**NO:** LS-078  
**DATE:** July 2015

**PRODUCT:** D4JL-SK40 Slide Key  
**TYPE:** Modification Notice

## Slide Key D4JL-SK40 Modified to Standardize Hole Shape

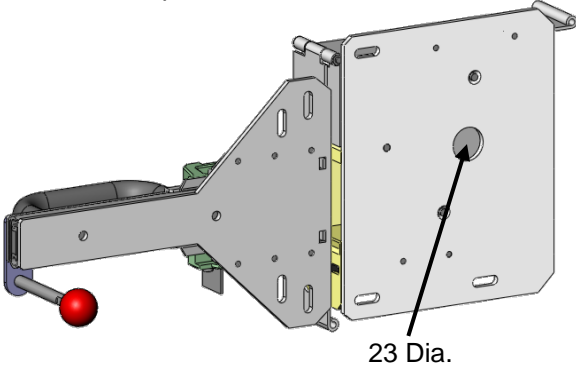
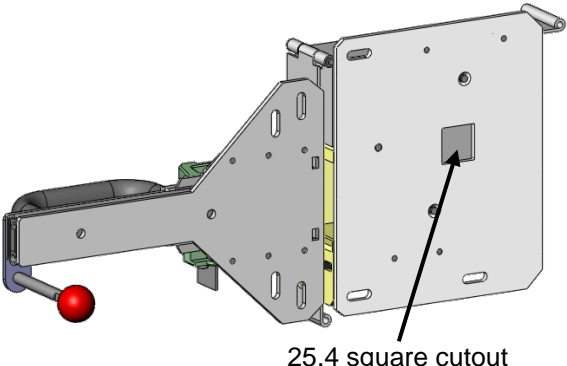
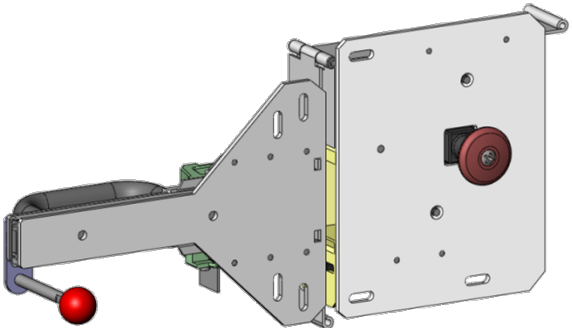
Before the change	After the change
<p data-bbox="289 247 415 277">Reference</p> 	<p data-bbox="850 247 1438 310">Similarly, Type D4JL-□□□A-06 can be mounted. * Special release key + Rear release buttons type</p>

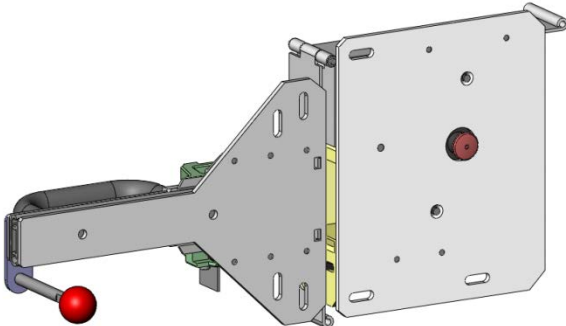
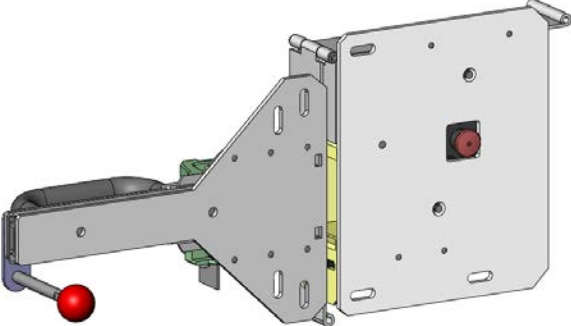
Before the change	After the change
<p>● <b>Hole shape change.</b> Circle shape *23 Dia.</p>  <p>23 Dia.</p>	<p>Square shape *25.4 square cutout</p>  <p>25.4 square cutout</p> <p>This shape change, Type D4JL-□□□A-□8-01-SJ can be mounted. * Trapped key + Rear release buttons type</p>
